# CITY OF ALBUQUERQUE

Re: Certification Submittal for Final Building Certificate of Occupancy for  
Fastest Emissions, [J-10 / D002F]  
455 Coors Blvd. NW  
Architect's Stamp Dated 05/12/09

Re: Fastest Emissions, 455 Coors Blvd NW, Traffic Circulation Layout  
Engineer's Stamp dated 10-24-08 (J10-D002F)

**Re: Fastest Emissions, 455 Coors Blvd NW, Traffic Circulation Layout  
Engineer's Stamp dated 9-25-08 (J10-D002F)**

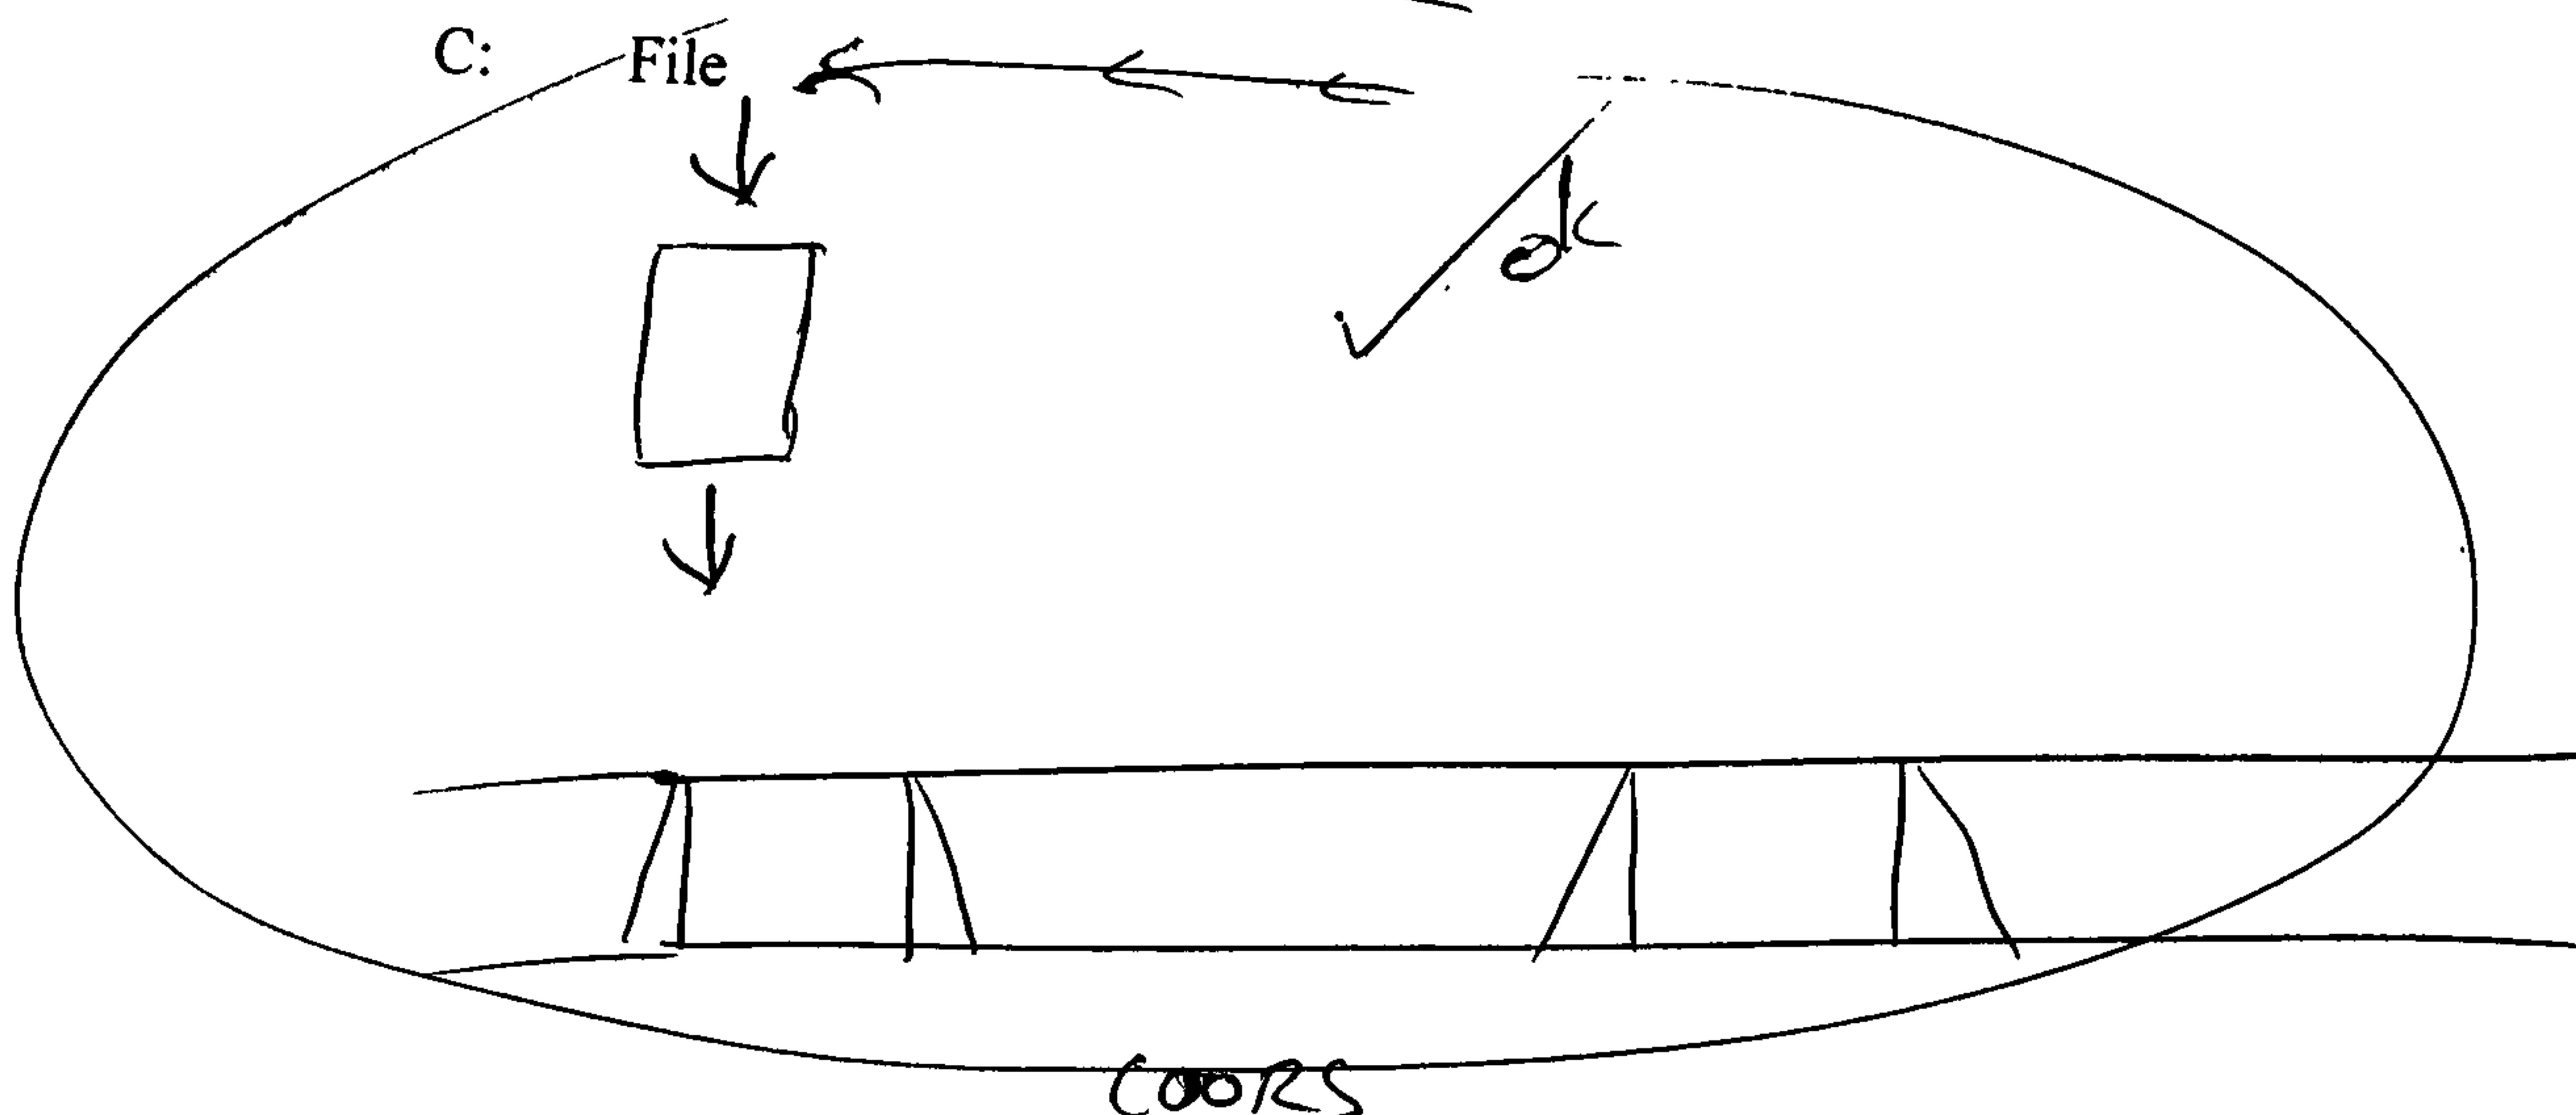
- A queuing length of 4 vehicle lengths (80 feet) must be provided for the proposed development. Your proposed layout is not acceptable, as the queuing would interfere with traffic attempting to enter and exit the site.
